NUREG-1423
Volume 10

A Compilation of
Reports of
The Advisory
Committee on
Nuclear Waste

July 1999 - June 2000

U. S. Nuclear Regulatory
Commission

Figure 2. Underground Repository Infiltration Shield

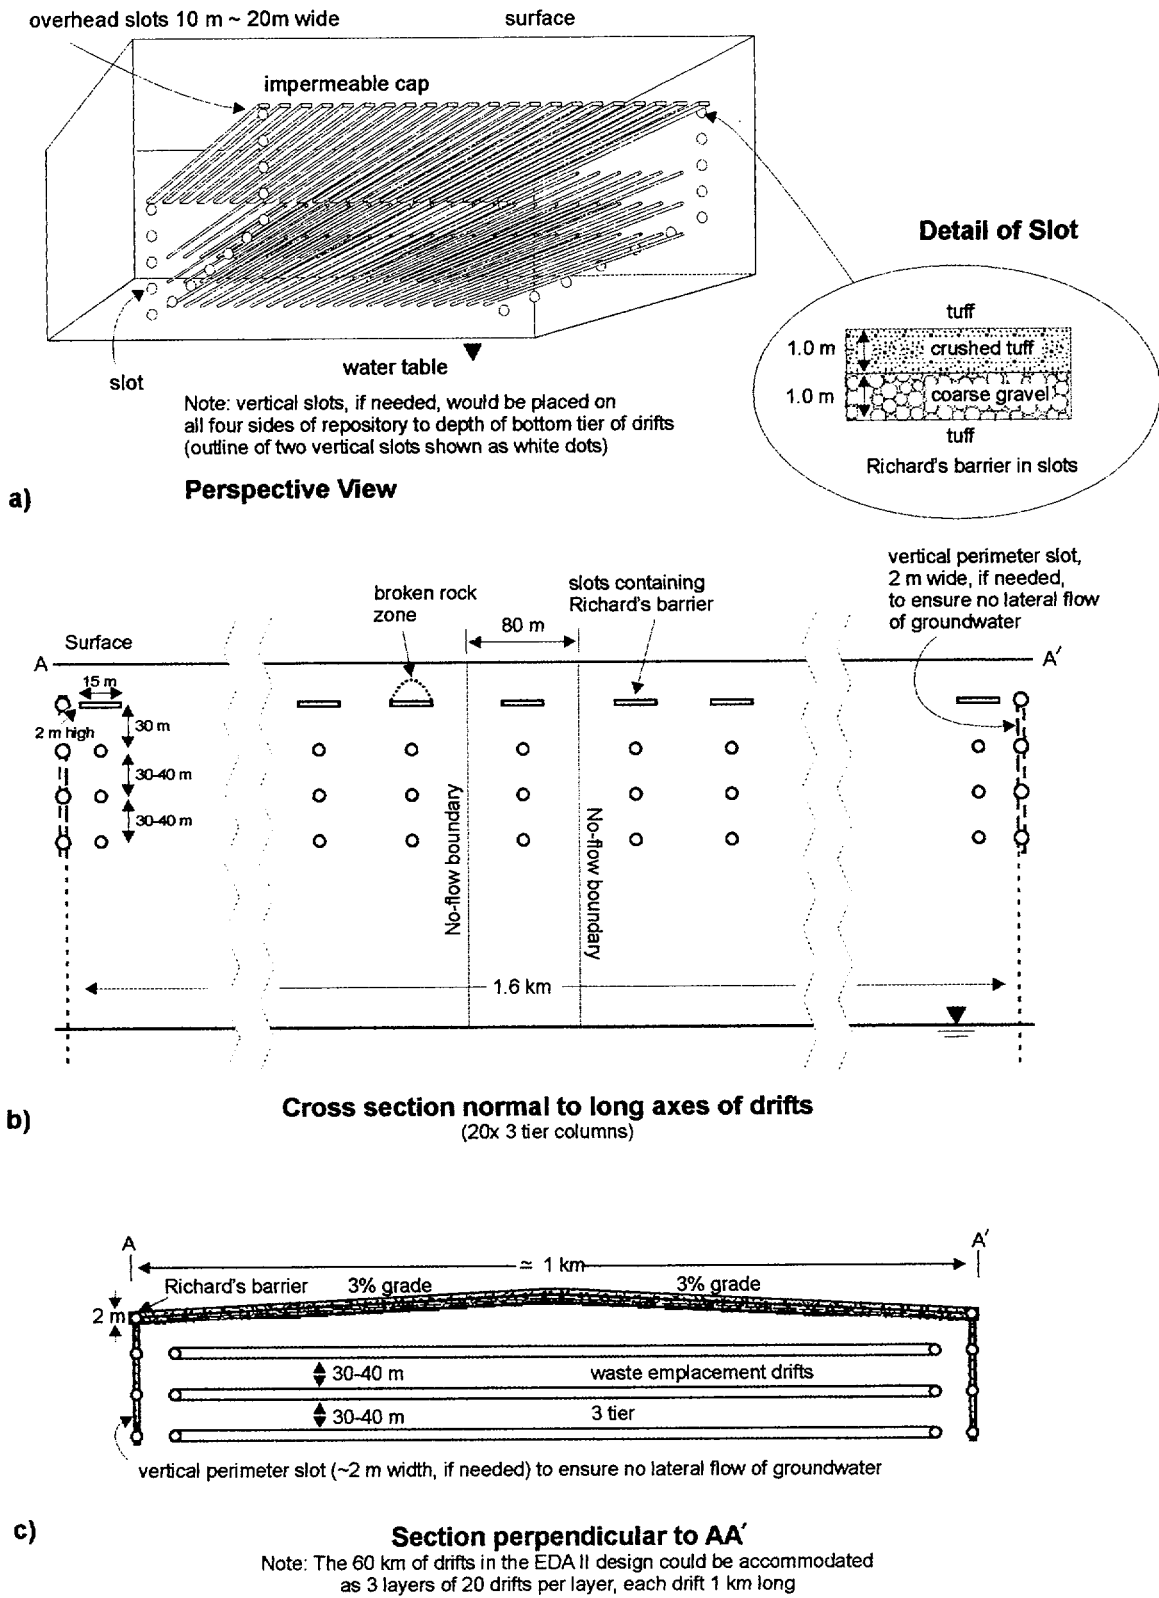
For a repository shield to be most cost effective, the repository should be a multi-level (three-tier or two-tier) design. (Figure 2 shows a three-tier design.) The shield appears to have the potential of greatly reducing water infiltration to the repository drifts—with attendant reduction of doses and simplification of performance assessment calculations. Construction of a flow diversion barrier in the (radiation-free) slot excavations above the drifts would be simpler than remote placement around the unshielded waste packages in the repository drifts—as currently proposed by DOE. If water infiltration is reduced to the extent predicted by analysis to date (see Appendix I), the expensive titanium drip shield (see Figure 4) may not be required. The presence of the drainage slots directly above the emplacement drifts may also simplify near-field fluid-flow and reflux processes during the thermal cycle. The concept deserves serious examination by DOE and its contractors.

The infiltration shield concept is illustrated in Figure 2. In the example shown, the repository is laid out as a three-level system.⁵ This alone, by reducing the plan area (*footprint*) of the

A single typical column of drifts was analyzed. This corresponded to the central column shown in the upper diagram in Figure 2, but with the upper slot replaced by a circular drift (see diagram in Appendix I). The flow conditions and rock mass properties were considered to be representative of those in the unsaturated zone at Yucca Mountain. It was assumed that the rock mass could be considered to behave as an anisotropic continuum (i.e., discrete fractures were not considered). A uniform vertical infiltration of 50 mm/yr ($1096 \times 10^{-5} \text{ m}^3/\text{d}$ over the 80 m^2 potential capture area (per meter of drift) was assumed to occur 30 m above the top row of drifts. A wide range of hydraulic anisotropy was examined. For all anisotropies considered, at least 94% of the top infiltration bypasses the lower three (rows of) drifts. The fluid pressure head above the lower drifts is reduced because of the proximity of the overlying drift, thus enhancing the potential for diversion of water around the lower drifts.

This criticism can be circumvented if the upper drift is replaced by a slot, say, 2 m high and ~10 m—20 m wide. Each such slot could be inclined slightly, as shown in Figure 2, and backfilled so as to establish a *flow diversion barrier*, to ensure that any infiltration from above the slot would drain into the rock mass outside the perimeter of the repository. Excavation of the 15 m—20 m slot would serve a dual purpose. A zone of enhanced fracturing would tend to develop above the slot (this would be further enhanced during the thermal cycle after the repository is filled with waste.) Any water infiltrating into the zone would drain into the slot; any remaining flow would be directed into the rock mass away from the drifts. Thus, both mechanisms (capillary diversion around and fracture flow into the slot) act to prevent flow into the drifts.

A three-tier repository, as shown in Figure 2, would occupy a vertical interval of approximately 60 m~80 m in the Topopah Springs formation. Since the horizon proposed currently for the single-level repository is approximately at elevation 1080 m it appears that a three-tier interval from 1,040 m to 1,120 m in the central third of the current repository (see VA, Vol. 2, Fig. 4.21, p. 4-40) will remain well within the “groundwater surface plus 100 m” lower limit and within the “200 m cover” upper limit. The slot horizon would be some 30 m or so above the upper row of drifts, but this too will have almost 200 m of rock cover. Since the slot would contain no waste, a cover slightly less than 200 m is considered adequate.

It is instructive, in this regard, to consider the performance of a multi-level EDA II design, as illustrated in Figure 2. The switch to a "line load" of waste packages (i.e., with the packages placed essentially adjacent to each other along the drift) compared to a "point load" (packages separated by several meters along the drift) and a much increased spacing between drifts (81 m for EDA II; 28 m for the VA Reference Design), together with some (low) velocity ventilation of the EDA II drifts, was intended to simplify the convective flow paths with reflux via the cool region in the center of each pillar.

Figure 4. Near-Field Engineering Measures to Prevent Dripping on to Waste Packages (It is planned to place the backfill in two layers as a Richards Barrier, with fine-grained rock material overlying a coarser-grained rock material.)

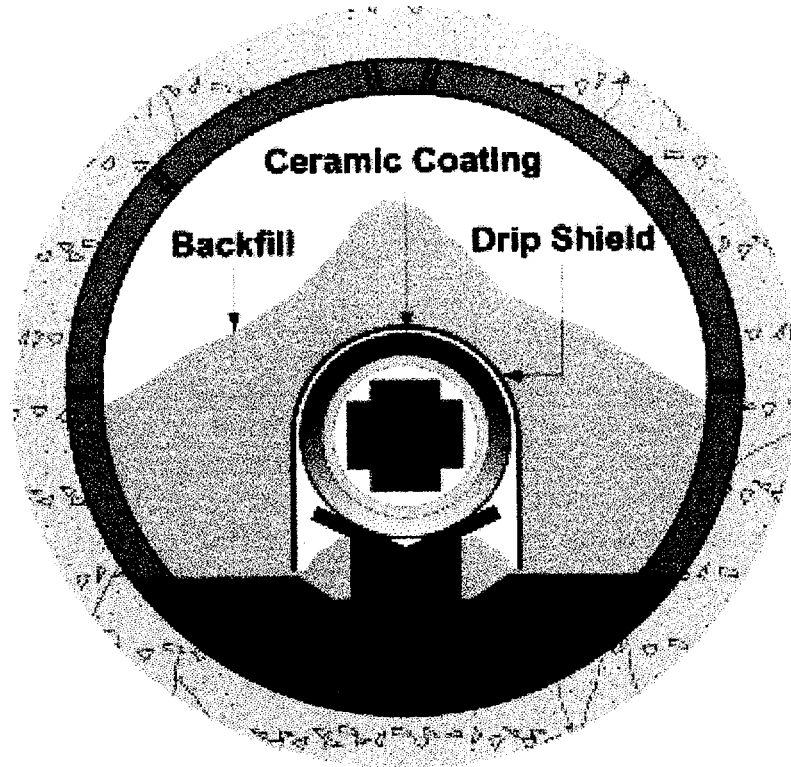
The distinct possibility that the repository shield concept could reduce drift infiltration sufficiently to make the titanium drip shield (Figure 4) unnecessary — for a cost saving of \$4.6 billion — strongly suggests that the repository shield concept deserves detailed study by DOE. Such a study should examine the implications of the multi-level arrangement (with overlying slots) on the optimum repository design.

Figure 5. Heat removed by continuous ventilation of waste-filled drifts during the pre-closure period (2m³/s air flow in a 5-m diameter drift corresponds to an air velocity of 20 ft/min, or 0.23 mph)

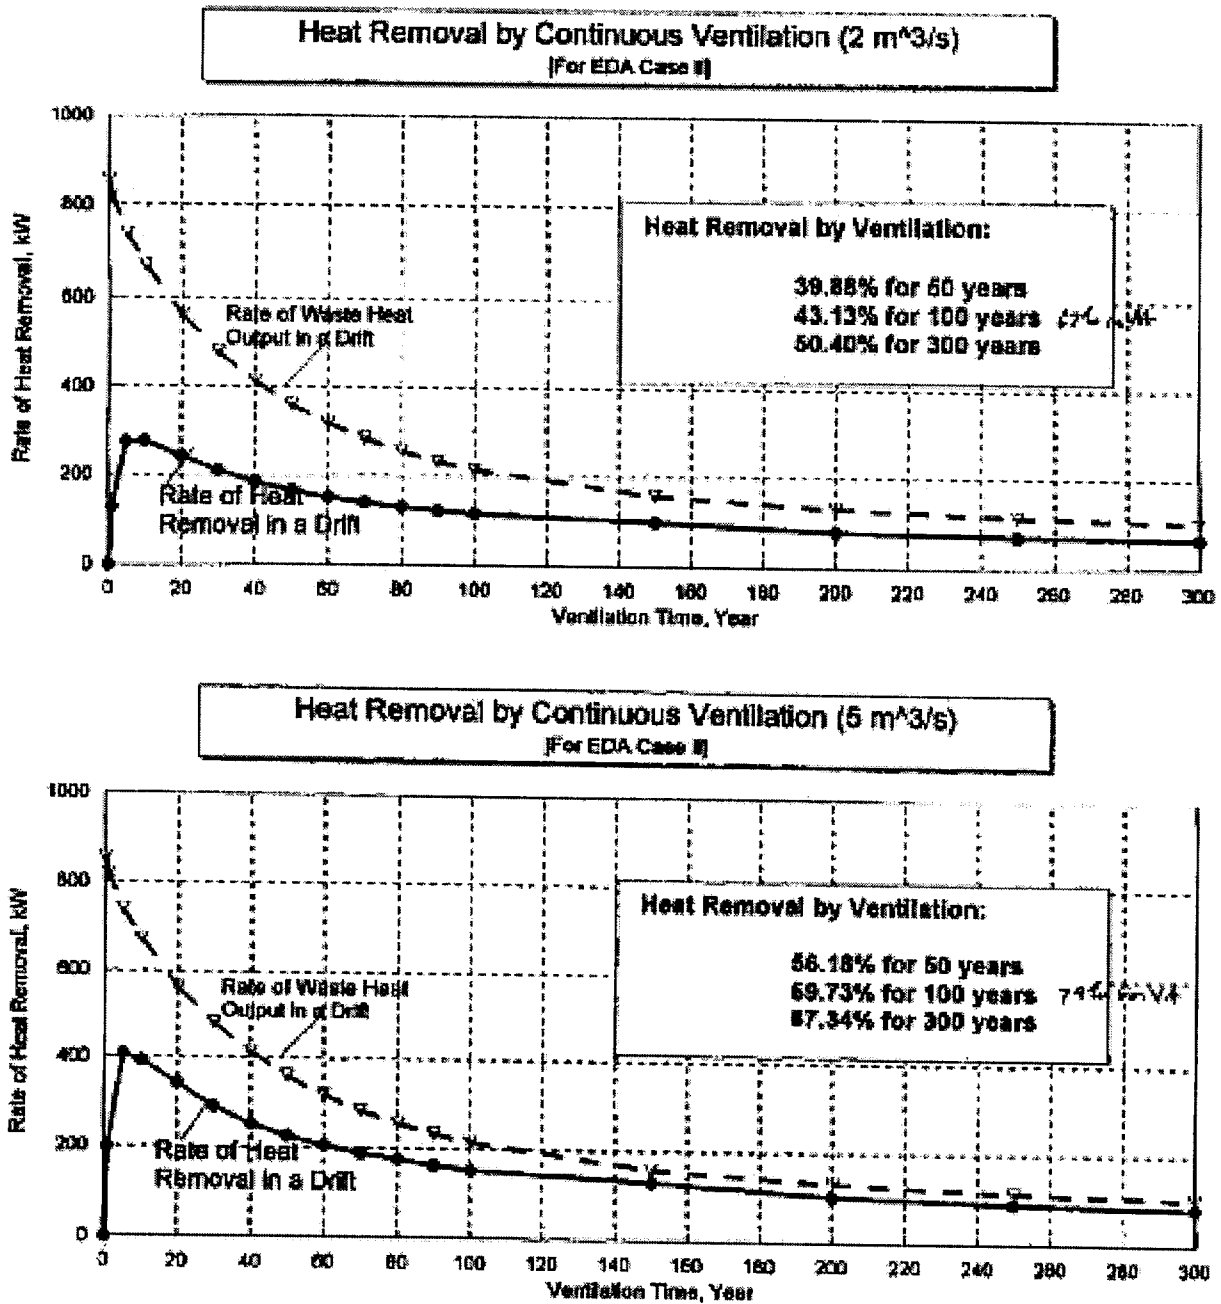
Figure 5 (kindly provided by the DOE, courtesy of R. Craun, 1999) indicates that drift ventilation can remove significant quantities of heat from the waste packages, especially during the first 50~100 years, when heat generation is most intense. Figure 6 (courtesy of D.G. McKenzie, April 1999) indicates that, with the EDA II design, drift ventilation of 2 m³/s, and no aging of the waste:

Figure 1. Waste Package and Drift Design Cross Section

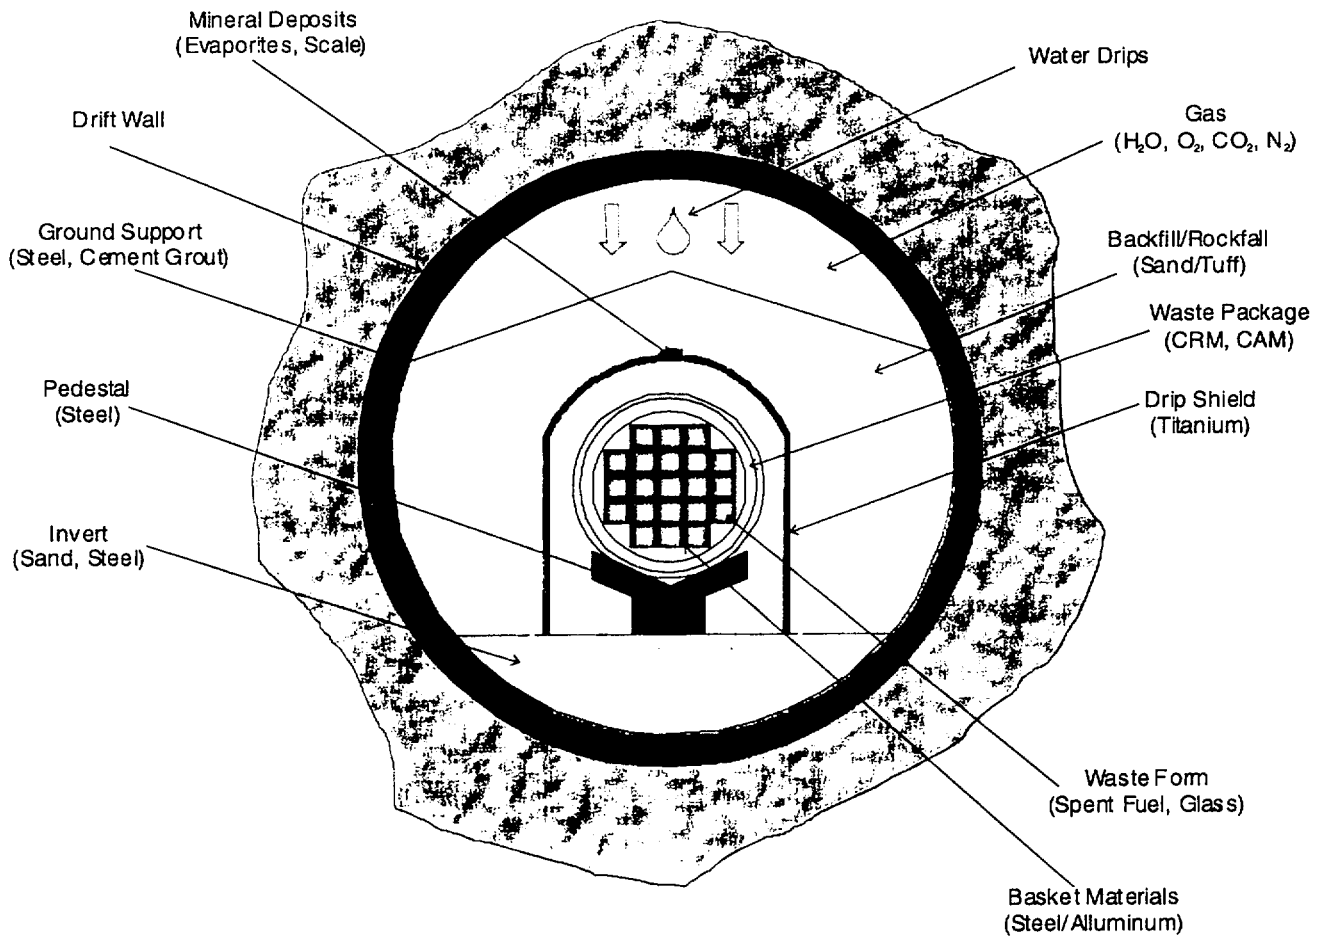
The current waste package design is shown in cross section Figure 1. The outer container has a 2 centimeter-thick wall of alloy C-22, whose composition is given in table 3. The inner container has a 5 centimeter-thick wall of stainless steel. It is expected that the stainless steel will corrode much faster than the C-22 once water breaches the C-22, and that in times far shorter than the repository licensing period it will be completely oxidized provided that the C-22 is in fact breached. As noted above, this steel could produce locally reducing conditions in the waste package or drift, and if oxidized, will add to the ionic iron content of the water. (Iron corrosion products would occupy more volume than the stainless steel from which they come, leading to potential adverse mechanical and structural effects. However, these effects are not considered here.) Unlike the steel in the waste package support and the steel invert, the iron ions from the stainless steel in the waste package container will be available for chemical reactions with the waste form itself at the water-waste interface.

There are extensive sources of information and data on the corrosion of high-nickel alloys, some of which are similar to C-22 (Betteridge, 1984; Schweitzer, 1996; INCO Inc., 1969 and 1995), but none for anything approaching the lengths of time being considered for the lifetime of the waste packages. The corrosion data that do exist for C-22 are very encouraging. However, pit, crevice, and stress corrosion are still matters of concern, and a better understanding of the mechanisms involved in these corrosion processes is needed before credit can be taken for the very long-term protection that DOE may postulate in its LA.
